Notice of Intent

Type of Submission: Notice of Intent	Type of Action: Plug and Abandonment
Date Sundry Submitted: 08/03/2021	Time Sundry Submitted: 10:42
Date proposed operation will begin: 08/03/2021

Plug and Abandonment Procedure
for
DJR Operating, LLC
South Bisti 21 H 2
API # 30-045-34131
SW/NE, Unit G, Sec. 21, T25N, R12W
San Juan County, NM

CONDITIONS OF APPROVAL

Proposed Wellbore Diagram

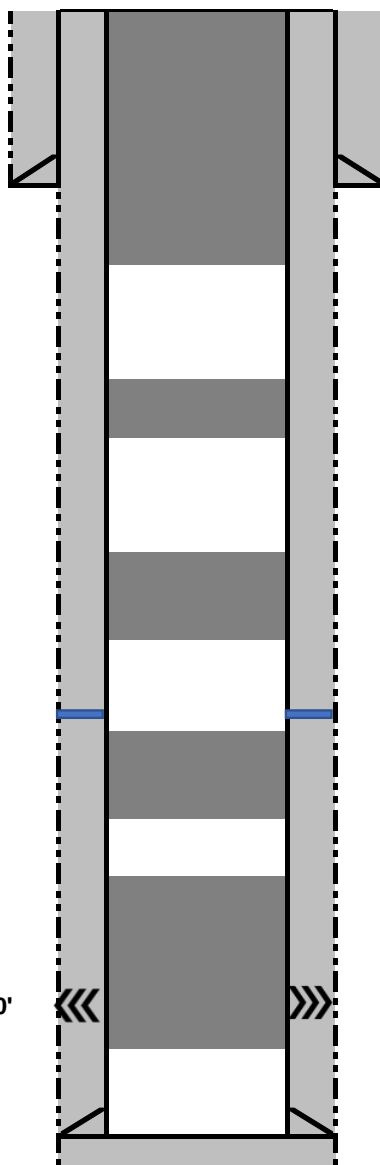
1. Plugging operations authorized are subject to the attached "General Requirements for Permanent Abandonment of Wells on Federal and Indian Lease."
2. Farmington Office is to be notified at least 24 hours before the plugging operations commence (505) 564-7750.
3. The following modifications to your plugging program are to be made:
 - a) Plug 3 and Surface Plug from the P&A Procedure will have to be readjusted to cover the BLM formation top picks. See attached geologic report.

- BLM geologist's estimates for the tops of the Chacra and Mesa Verde fms. vary from operator's estimates in this well.

-The top and/or bottom of Plug 3 and the Surface plug vary from the BLM geologist's formation depths. These plugs must be modified to match the BLM depths.

You are also required to place cement excesses per 4.2 and 4.4 of the attached General Requirements.
